New Albany Architectural Review Board Meeting Agenda
Monday, March 13, 2023 7:00pm

LOCATION: 266 East Main Street (PID: 222-000089)
APPLICANT: Sarasheen Partnership LLC, c/o Tom Sheehan
REQUEST: Certificate of Appropriateness
ZONING: Infill Planned Unit Development (I-PUD) within the Urban Center
STRATEGIC PLAN: Village Center
APPLICATION: ARB-22-2023

LOCATION: 7600 Fodor Road (PID: 222-000922)
APPLICANT: Anders Samuelson, Mannik Smith Group
REQUEST: Certificate of Appropriateness
ZONING: Urban Center District within Village Center – Campus Subdistrict
STRATEGIC PLAN: Village Center
APPLICATION: ARB-33-2023

LOCATION: Taylor Farm Park (PID: 222-005165)
APPLICANT: City of New Albany c/o Adrienne Joly
REQUEST: Certificate of Appropriateness
ZONING: Agricultural (AG)
STRATEGIC PLAN: Parks and Green Space
APPLICATION: ARB-34-2023

EXTERIOR CANOPY ADDITION

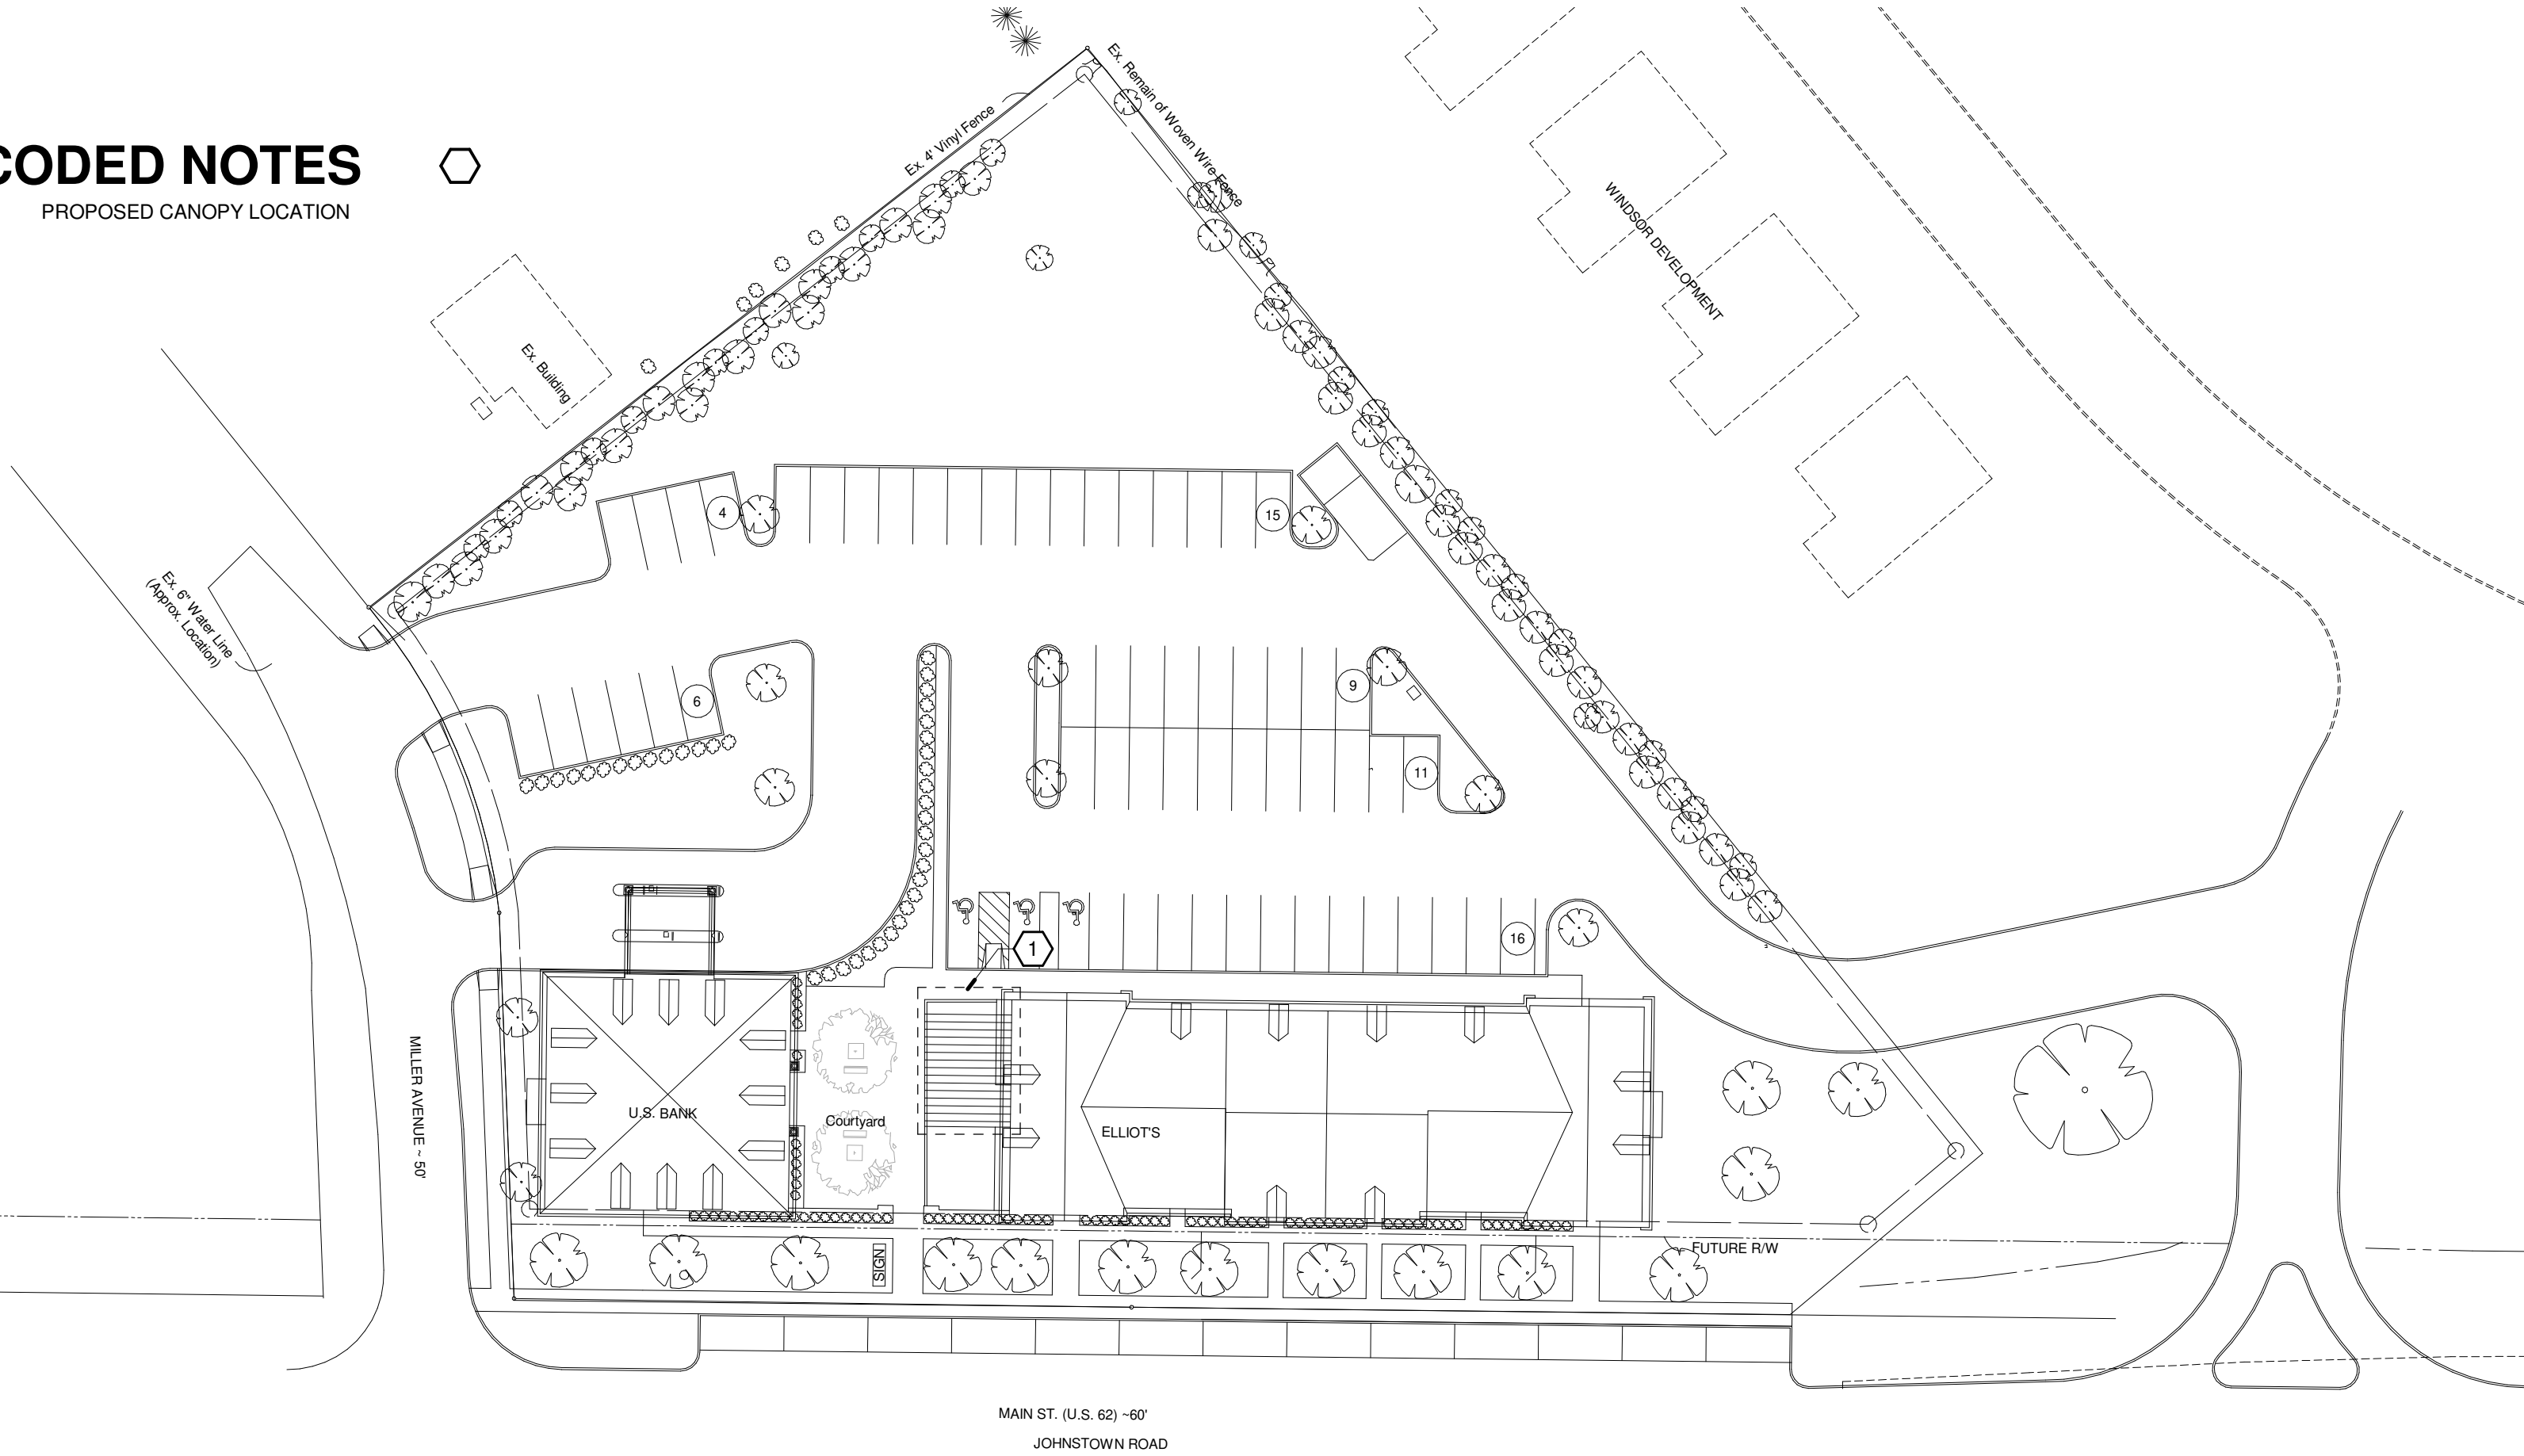
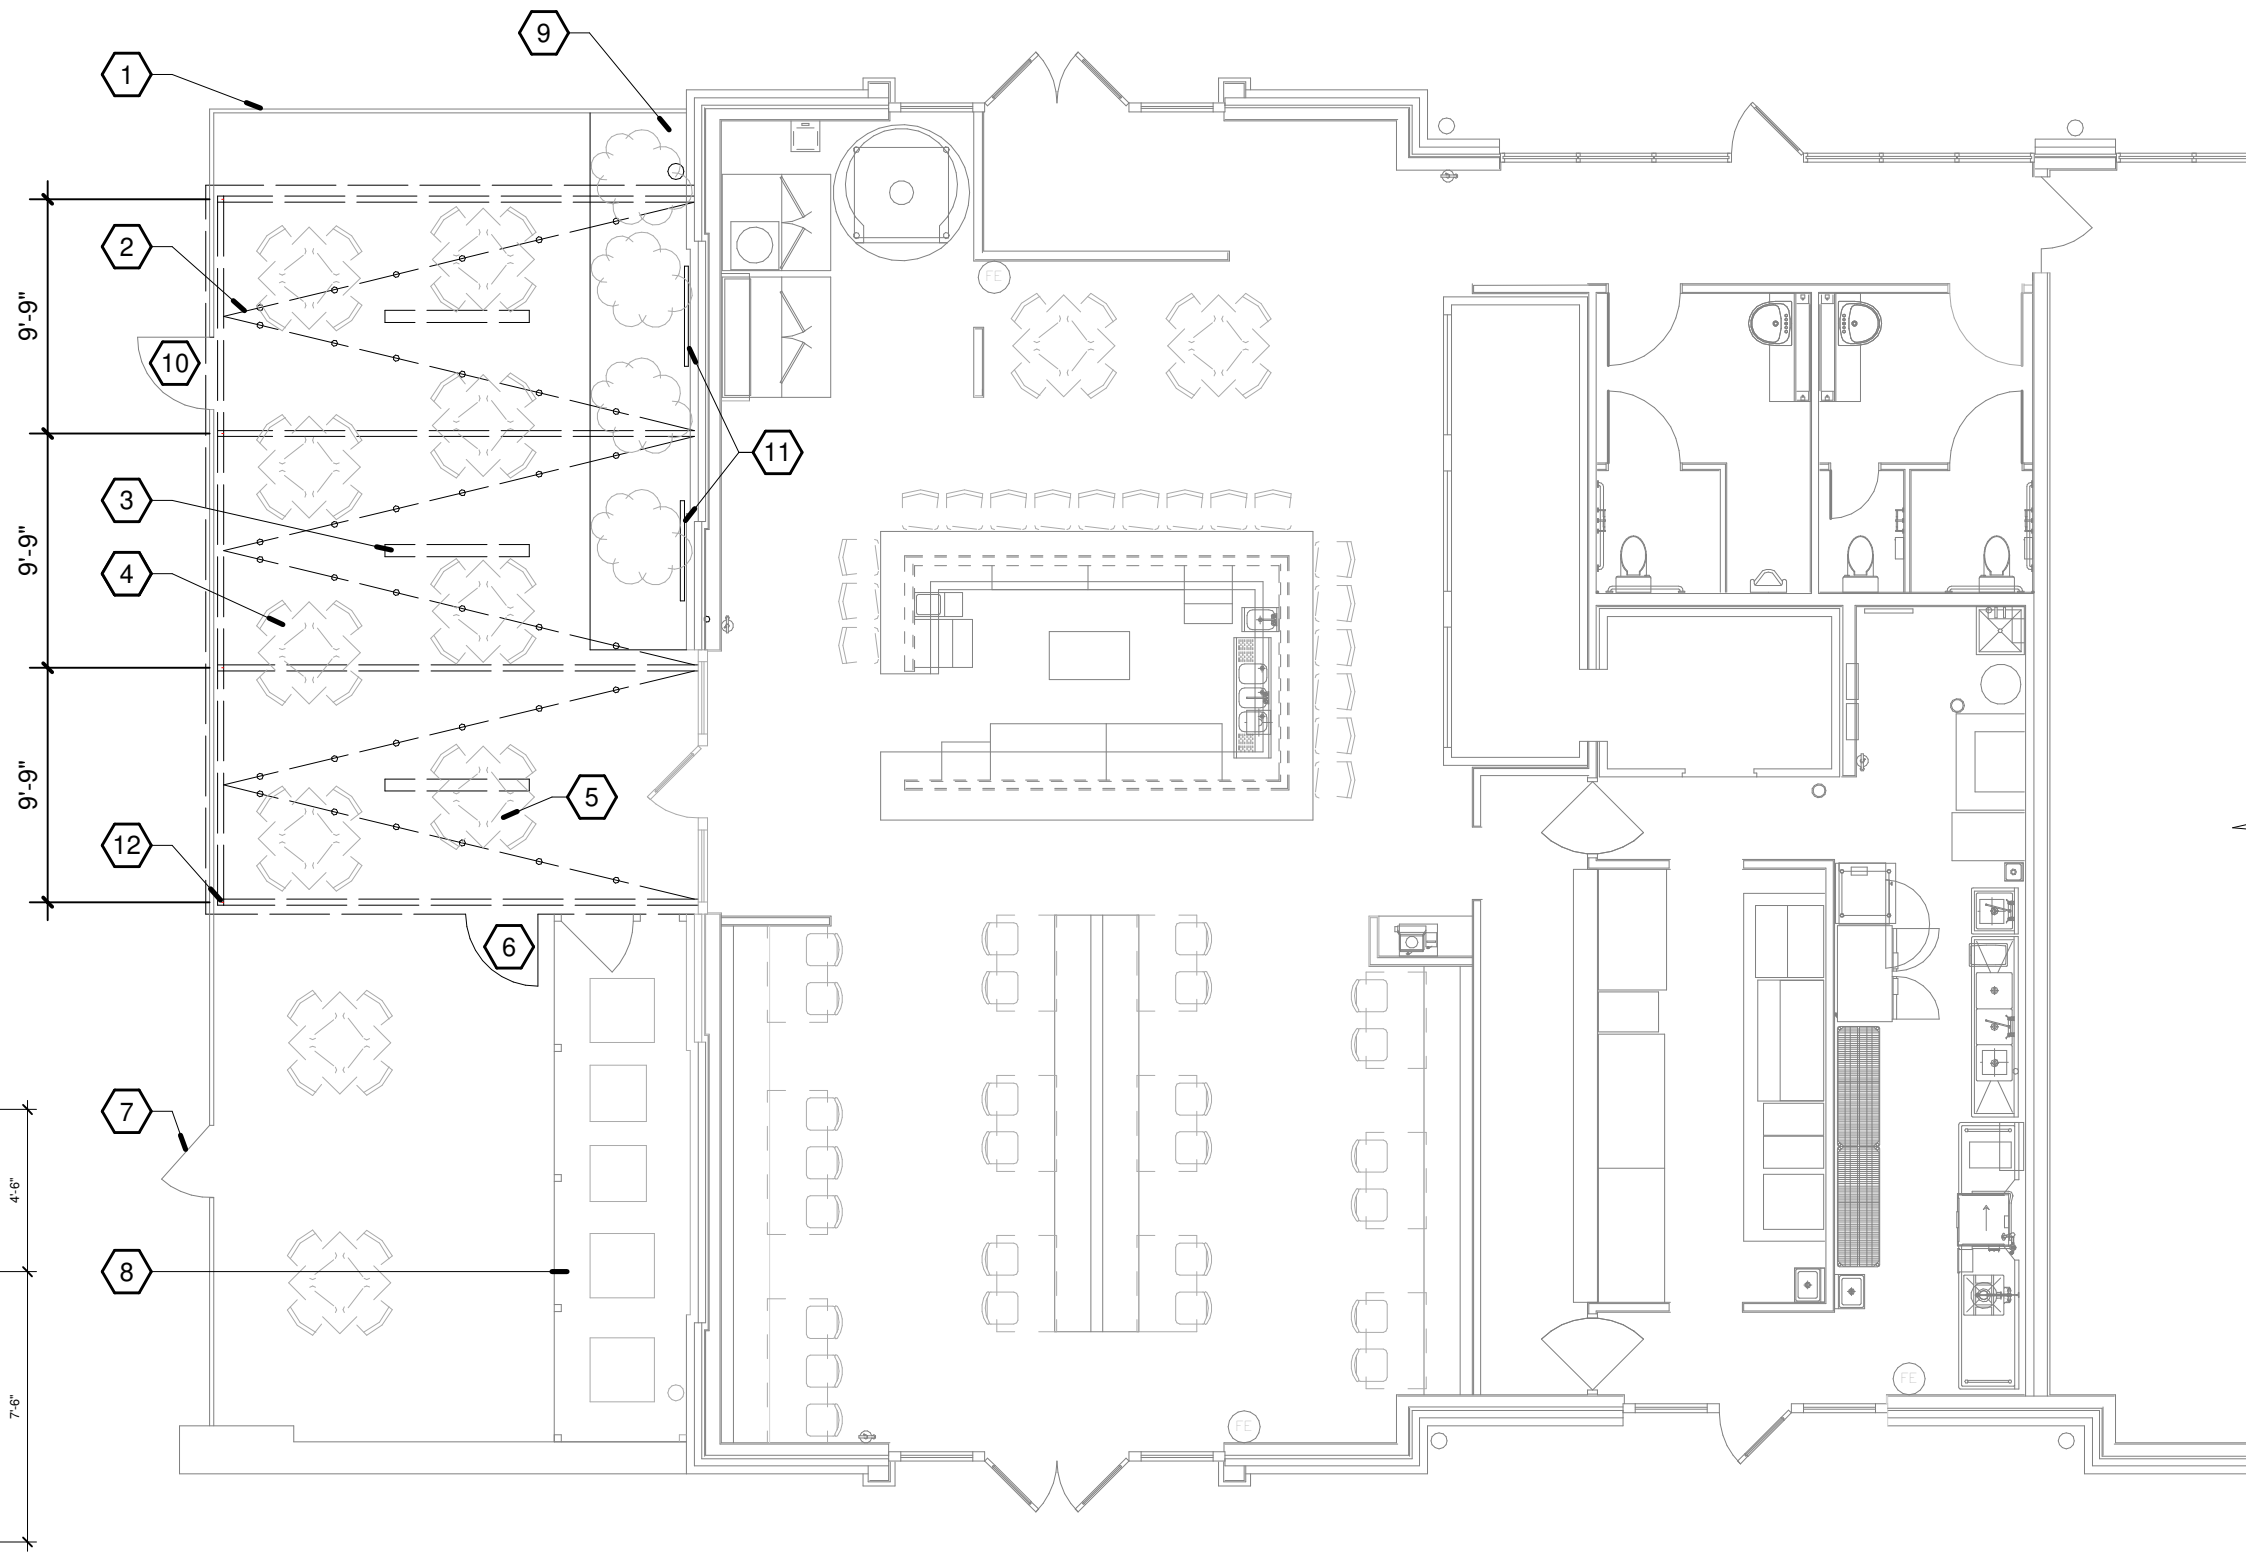
1. *The compliance of the application with the Design Guidelines and Requirements and Codified Ordinances.*
 - The existing patio is located within the courtyard area of the development and serves as outdoor seating for Elliot's. A single door provides access to the patio from the restaurant. One existing egress gate is in place and second egress gate will be added for the patio. The current entrance to Elliot's will remain as the primary business entry.

The canopy addition is proportional to the building and the patio area, and its location within the site is appropriate. Overall, it seems that construction of this canopy will enhance the quality of the business, building, and surrounding area by “activating” the public space year round and contributing to the urban character that is desired in the Village Center. The canopy details help aesthetically harmonize the canopy with the building by complementing the architectural detail lines from the building’s façades and brick soldier course. Consistent with the development text requirement, this canopy exhibits 360-degree design and balances the architecture of the main building.
